**ADDISON AIRPORT
BUILDING REPORT**

Facility Information: **Facility Name:** 4555 Glenn Curtiss Drive

Inspector: Karen Jackson **Date:** May 3, 2017

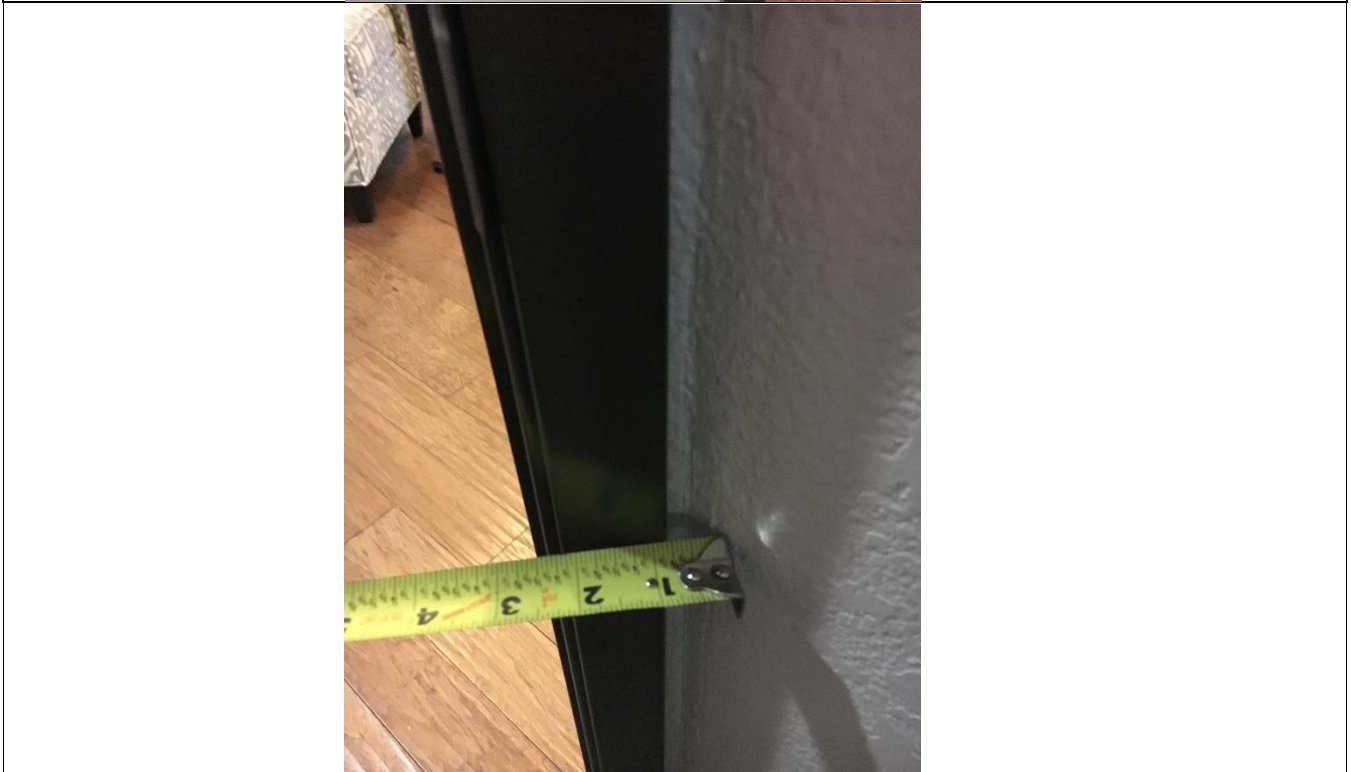
Violation 1 - There are two accessible parking spaces provided at the side of the building, neither of them are designated as van accessible.

Violation 2 - There are no accessible parking spaces provided in the back hangar parking area.

Violation 3 - The accessible parking is not located on the shortest accessible route to the main entrance. There are no accessible spaces in the front lot to serve the main building entrance.

Violation 4 - The route from the front parking lot to the building is not compliant. The parking lot as well as the sidewalk leading to the main building entrance has excessive slopes.

Add van accessible signage to the right accessible space. Restripe the access aisles so it is 96" wide to serve the accessible parking space that will be designated as "van accessible."

Add a van accessible parking space, access aisle and complaint parking signage.

Add accessible parking, access aisle and parking signage to the front parking area.

Repave that path of travel leading from the front parking area (where accessible parking should be provided) to the building entrance.

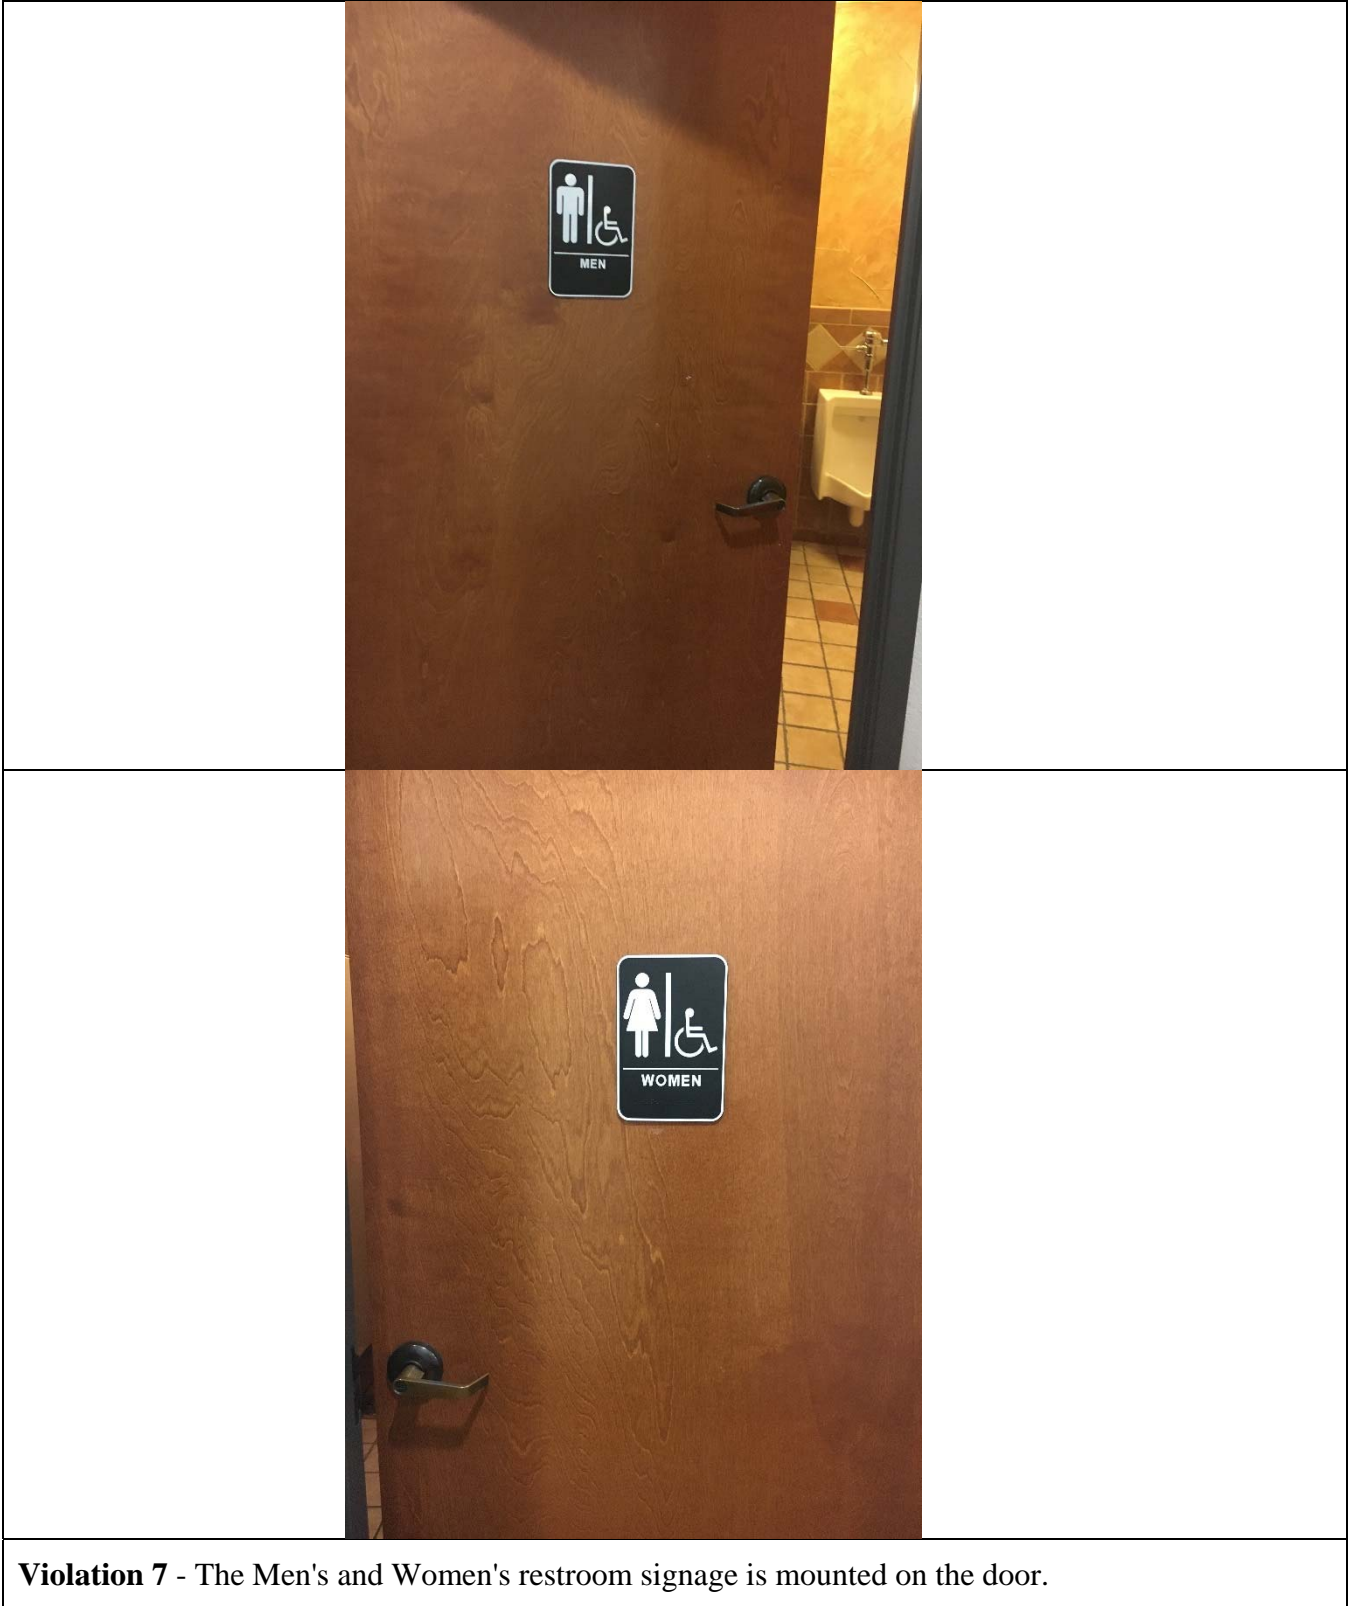
Violation 5 - The main entrance has a broken concrete resulting in a change in level greater than 1/4".

Violation 6 - The two front offices do not have a minimum of 18" maneuvering clearance on the pull side of the doors.

Remove and patch the broken concrete at the front entrance to achieve a smooth, level transition.

Reverse the swing of the doors.
